City of Alachua

Planning & Community Development Department Staff Report

SUBJECT: A request for a Site Plan to construct a $\pm 7,500$ square foot building addition with parking, stormwater, landscaping, and site improvements

RE: Development Review Team (DRT) Comments: Dreyer's DKI Site Plan

SHEET 1 OF 5 SITE & DIMENSION PLAN
 SHEET 2 OF 5 GRADING & UTILITY PLAN
 SHEET 3 OF 5 LANDSCAPE PLAN
 SHEET 4 OF 5 LANDSCAPE PLAN
 SHEET 5 OF 5 LANDSCAPE PLAN
 PAGE 1 OF 5 ARCHITECTURAL BUILDING ELEVATIONS
 A2.0

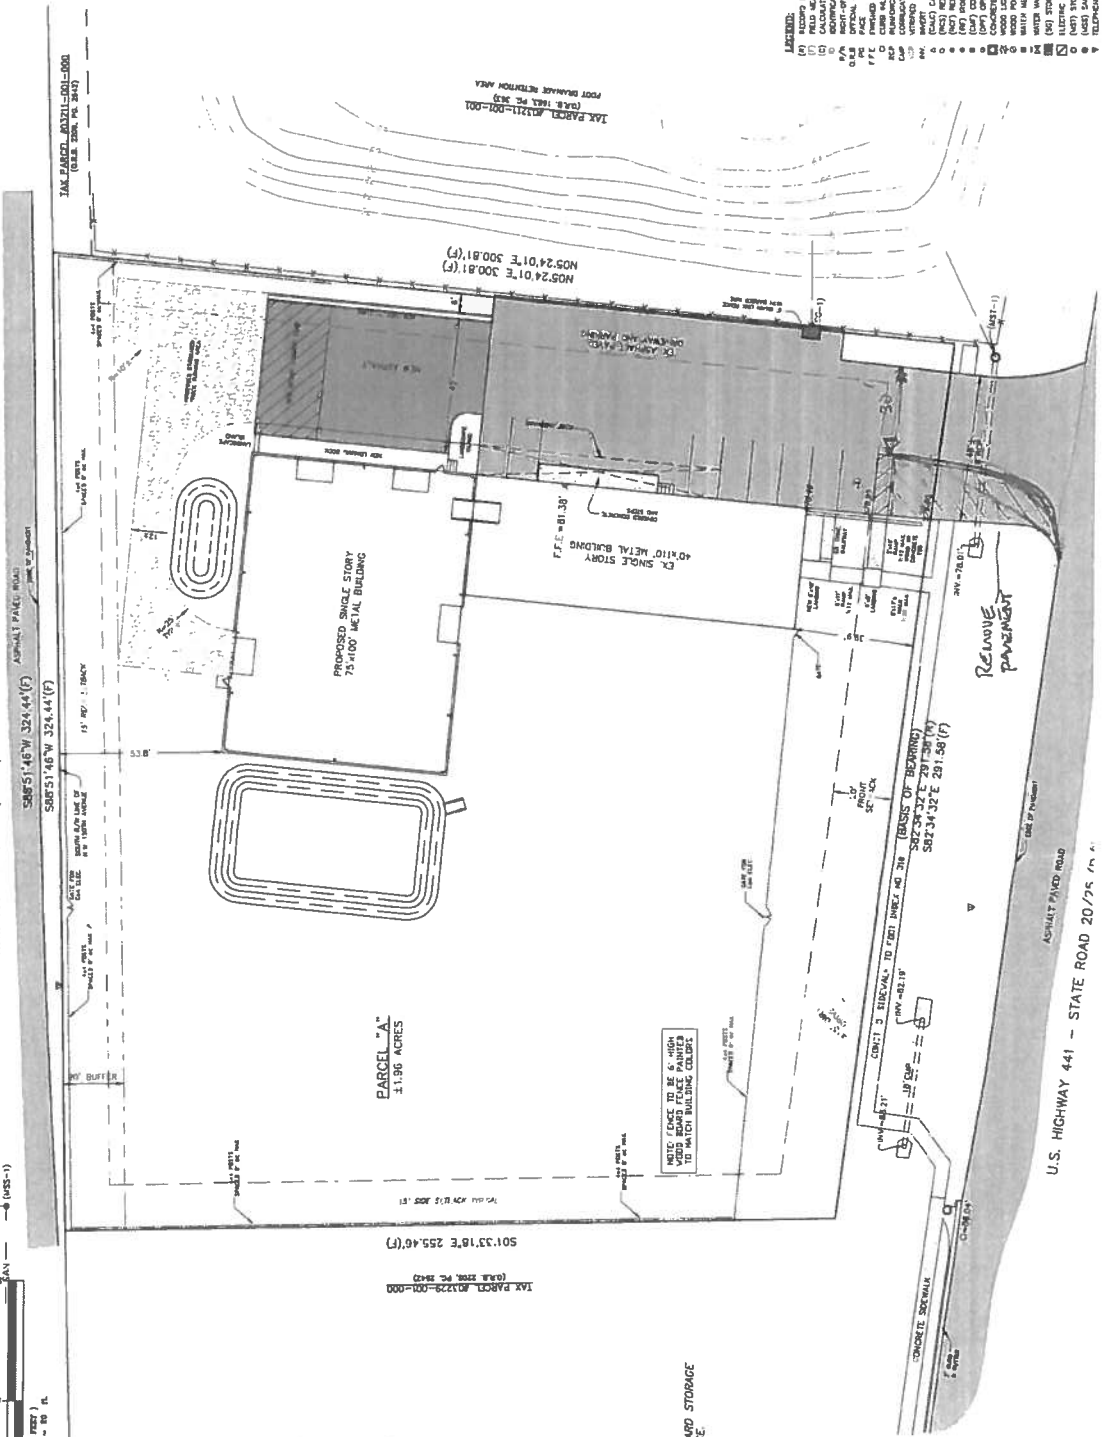
- a. Parking calculations on Sheet 1 utilized a parking standard of 1 space per 350 square feet of floor area for office area and 1 space per 1,000 square feet of warehouse area.
 - i. The use of the property is classified as "General Industrial Service". The minimum parking standard per Table 6.1-1 for this use is 1 space per 1,500 square feet of floor area.
 - ii. The minimum number of parking spaces per Table 6.1-1 is 8 spaces. The maximum number of parking spaces per Section 6.1.4(B)(5) is 10. 19 spaces are proposed. Please address.

RESPONSE: Eight (8) parking spaces have been shown on Sheet 1.

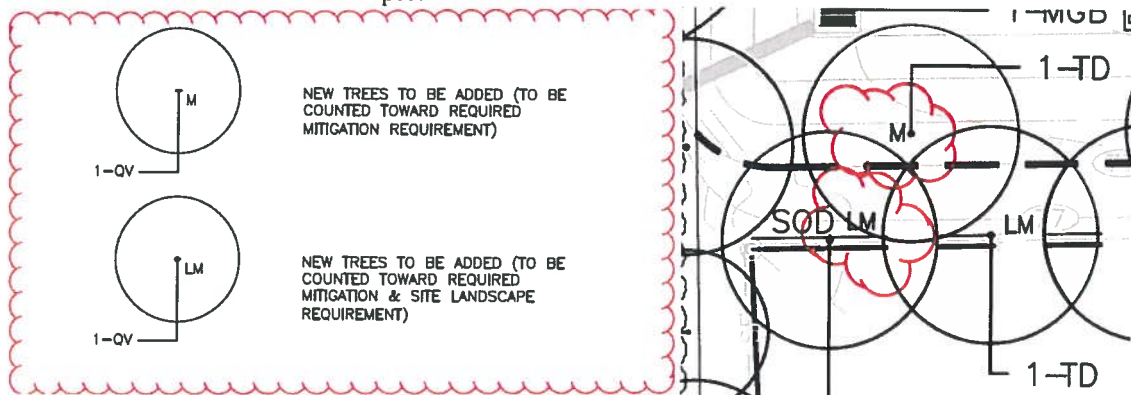
Remaining Insufficiencies: The applicant's response letter states, "[n]o 'permanent' dumpster pad will be located on site. A 'roll off' dumpster will be utilized and located at the northeast corner of the proposed parking area as needed." In addition, the applicant's response to the residential protection standards as set forth in Section 6.6.3 states "[a]

temporary "roll-off dumpster" or "dump trailer" is proposed at the easterly end of the new loading zone approximately 70' from the property line."

- i. Section 6.2.3(B) requires waste receptacles to be screened. Any "roll off" dumpsters which are located on-site on a recurring basis must be screened in accordance with this section. In addition, as discussed at the DRT Meeting, Staff will recommend a condition requiring all waste receptacles to be at least 50 feet from the north property line in order to address compliance with the standards of Section 6.6.3. The location as generally described by the applicant will not comply with Staff's recommendation.
- ii. The proposed location of the waste receptacle is not shown on the site plan. Identify the location of the waste receptacle on the plans.

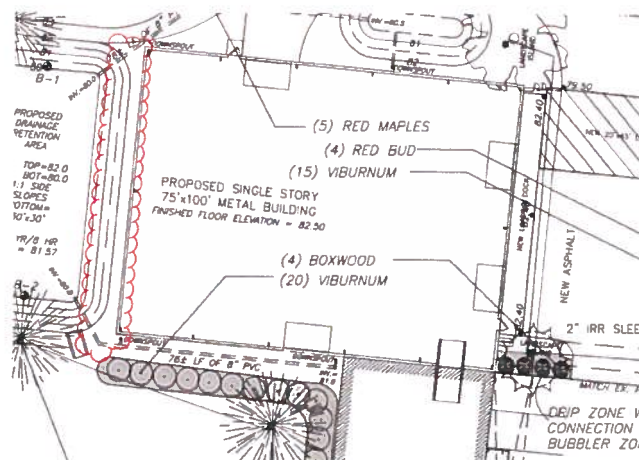
- b. Per Section 6.2.2(D)(1)(d)(iii), a row of shrubs shall be planted along the front and side facades of the primary structure, or shrub masses with three or more species shall be planted along such facades. This is applicable to the west side of the existing building, and the south and west side of the proposed building addition. Please address.

Remaining Insufficiencies: A row of shrubs is required along the west side of the proposed building addition but is not provided for on the plans. See below:

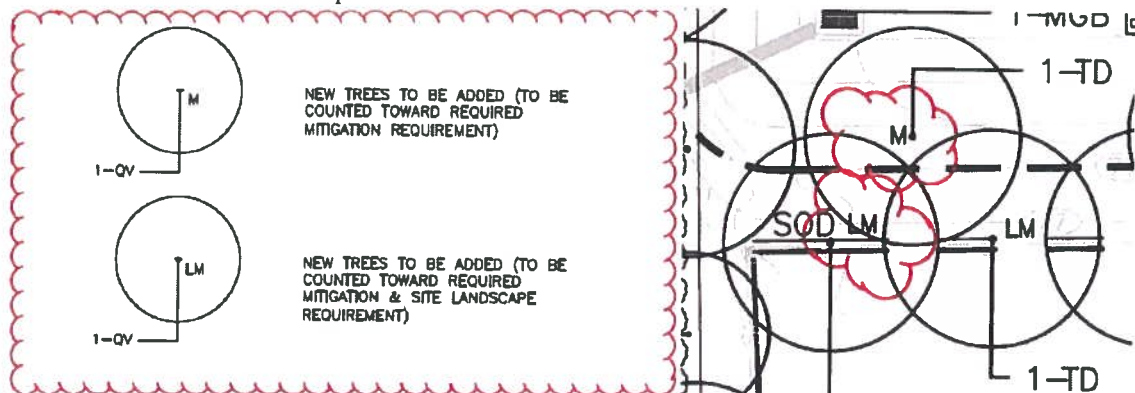
A temporary "roll-off dumpster" or "dump trailer" is proposed at the easterly end of the new loading zone approximately 70' from the property line."

- i. Section 6.2.3(B) requires waste receptacles to be screened. Any "roll off" dumpsters which are located on-site on a recurring basis must be screened in accordance with this section. In addition, as discussed at the DRT Meeting, Staff will recommend a condition requiring all waste receptacles to be at least 50 feet from the north property line in order to address compliance with the standards of Section 6.6.3. The location as generally described by the applicant will not comply with Staff's recommendation.
- ii. The proposed location of the waste receptacle is not shown on the site plan. Identify the location of the waste receptacle on the plans.

RESPONSE: A dumpster pad has been added to the plan sheets 50' from the north property line.

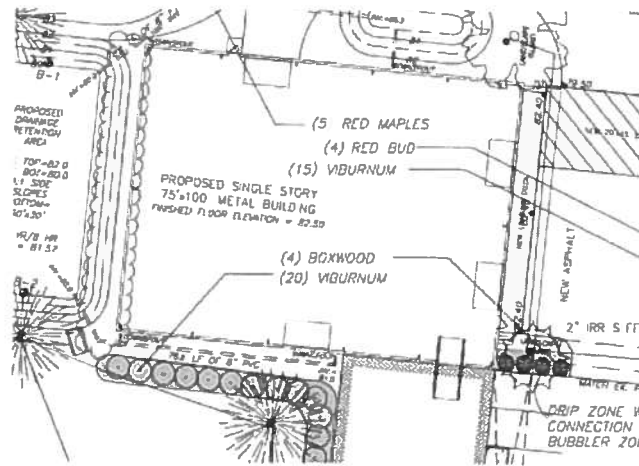
- b. Per Section 6.2.2(D)(1)(d)(iii), a row of shrubs shall be planted along the front and side facades of the primary structure, or shrub masses with three or more species shall be planted along such facades. This is applicable to the west side of the existing building, and the south and west side of the proposed building addition. Please address.

Remaining Insufficiencies: A row of shrubs is required along the west side of the proposed building addition but is not provided for on the plans. See below:

RESPONSE: Added a row of shrubs along west building side.
